**Proposal #07: 6050-00-71, WISC 2019 734
Wyocena - Montello
STH 16 to NCL / B-11-0171
STH 22
Columbia County**

This is Addendum No. 02, which provides for the following:

ADDENDUM NO. 02

Addendum No. 02
 ID 6050-00-71
 Revised Sheet 6
 December 4, 2019

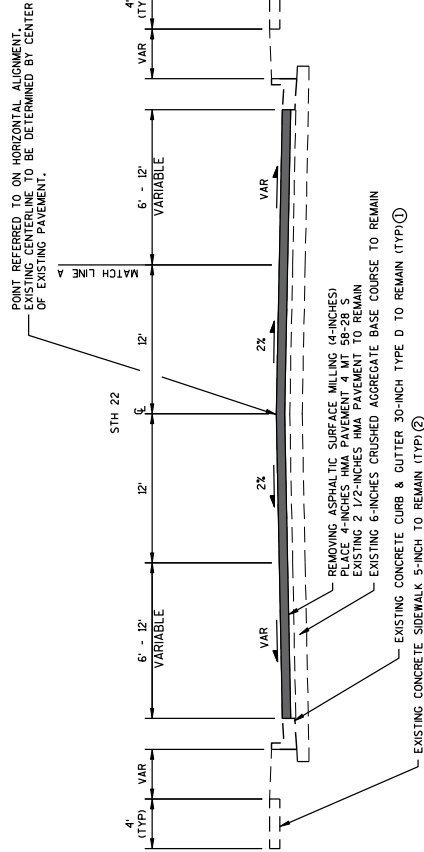
Revised Plan Sheets	
Plan Sheet	Plan Sheet Title (brief description of changes to sheet)
6	Typical Section - Updated reference to HMA mix type
148	Plan and Profile - Updated reference to HMA mix type

REMOVING ASPHALTIC SURFACE MILLING (6-INCHES)
 PLACE 4-INCHES HMA PAVEMENT 4 MT 58-28 S
 EXISTING 6-INCHES CRUSHED AGGREGATE BASE COURSE TO REMAIN
 BASE AGGREGATE DENSE 3/4-INCH (TYP)
